## **Access Compliance Report Public Rights-of-Way** (Curb Ramps)

Main Street: BALLANTYNE\_CORPORATE\_PCross Street: N/A Intersection ID: 10020377 Location: SE

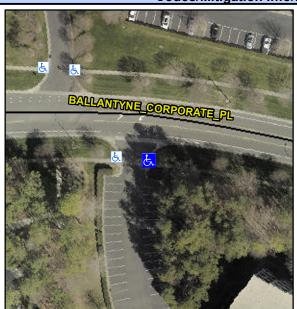
Initial Pass/Fail: Fail

**Overall Compliance: No**

**ENTRANCE** Street 1 Name Stop Condition-Street 2 StopSign N/A Street 2 Name Stop Condition-Street 1 N/A Possible Solutions: Compliance Description N/A Remove & Replace Entire Ramp. Yes N/A N/A N/A N/A Surveyor Notes: N/A N/A N/A N/A N/A N/A PROW/ADA: N/A Not Found, R304.2.2 N/A N/A N/A N/A
